Item Name: Crosstube Turning Detail

<b>DART AEROSPACE LTD</b>		<b>Work Order:</b>	101370
<b>Description:</b> Crosstube Assembly		<b>Part Number:</b>	D407-667-145
<b>Inspection Dwg:</b> D407-667-145 Rev: C		<b>Page 1 of 2</b>

DRAWING NO. D407-667-145	TITLE CROSSTUBE ASS'Y (407 HIGH FWD)	REV. C	DART AEROSPACE LTD ENGINEERING ORDER		D.E.O. NO. D407-667-145-C-1	SHEET NO. SHEET 1 OF 1	SCALE NTS
DRAWN <i>qp</i>	CHECKED <i>ASS</i>	MFG. APPR. <i>IB</i>	APPROVED <i>WD</i>		DE APPR. <i>##</i>		
DATE 11.07.15	DATE 11.07.22	DATE 11.07.22	DATE 11/07/22		DATE 11.07.21

DRAWING NO. D407-667-145	TITLE CROSSTUBE ASS'Y (407 HIGH FWD)	REV. C	DART AEROSPACE LTD ENGINEERING ORDER	D.E.O. NO. D407-667-145-C-2	SHEET NO. SHEET 1 OF 1	SCALE NTS
DRAWN AJS	CHECKED	MFG. APPR. <i>E</i>	APPROVED <i>AD</i>	DE APPR. <i>AD</i>		
DATE 12.08.02	DATE 12.08.02	DATE 12.08.02	DATE 12.08.02	DATE 12.08.02	DATE 12.08.02

**DETAIL P**  
 BONDING STRAP INSTALLATION 2 PL

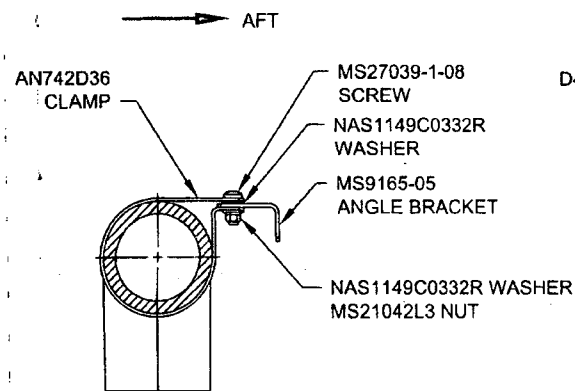
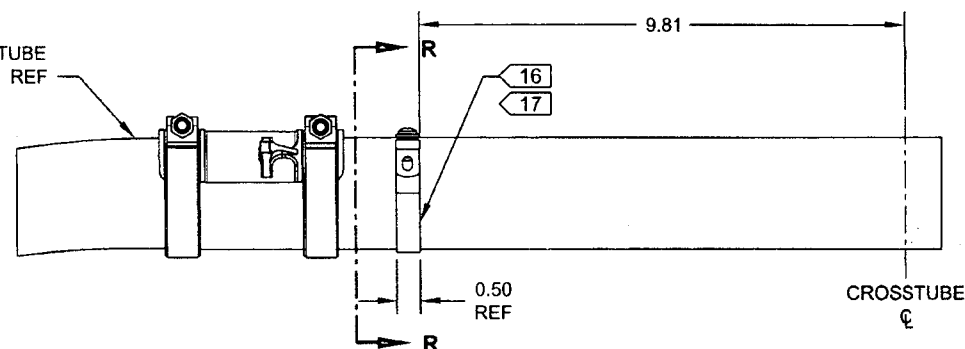
ADD ELECTRICAL GROUNDING STRAP

ITEM	QTY -145	PART NUMBER	DESCRIPTION
1	X	D407-667-145	CROSSTUBE ASSEMBLY (407 HIGH FWD)
10	2	AN742D36	CLAMP
11	2	MS9165-05	ANGLE BRACKET
12	2	MS21042L3	NUT (OR MS21042-3)
13	2	MS27039-1-08	SCREW
14	4	NAS1149C0332R	WASHER (OR AN960C10L)

- 16) MASK AREA UNDER CLAMP PRIOR TO PAINTING
- 17) SEAL EDGES WHERE AN742D36 CLAMP MEETS WITH THE CROSSTUBE USING SIKAFLEX-241/-291 OR MIL-S-8802 CLASS B2 OR PROSEAL 890 SEALANT
- 18) PERFORM RESISTANCE CHECK TO ENSURE MAX RESISTANCE IS 10 MILLIOHMS
